# *Bulls Eye Home Inspection, PLLC*

## Phase Inspection Report

# Pre-Pour Checklist

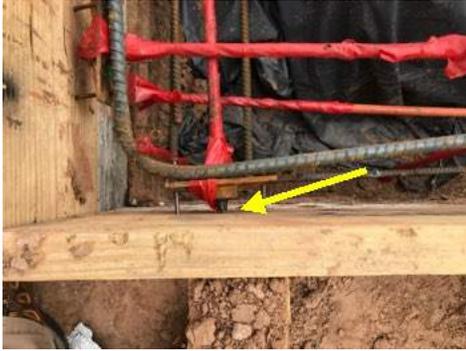
The sheathing on multiple tendons was damaged/ cut short and left the strands exposed to being in contact with the concrete. The tendons should be greased and taped prior to placing the concrete.

A tendon was found to be in contact with a PVC pipe (drain/vent). This could put stress on the

pipng when the tendons are put under tension, risking damage to the piping. This should be corrected prior to placing the concrete.

One or more tendon was found to be in contact with the form work. A 3/4 of inch gap should be left between the tendons end and the formwork. This should be corrected prior to placing the concrete.

One or more tendon had the cable end taped. There should be a minimum of 12" unwrapped on the tendons fixed end. This should be corrected prior to placing the concrete.

Sheathing tear

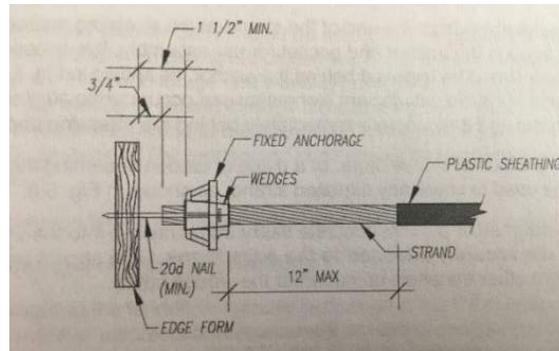
Sheathing tear

Not tied

Fixed end assembly installation
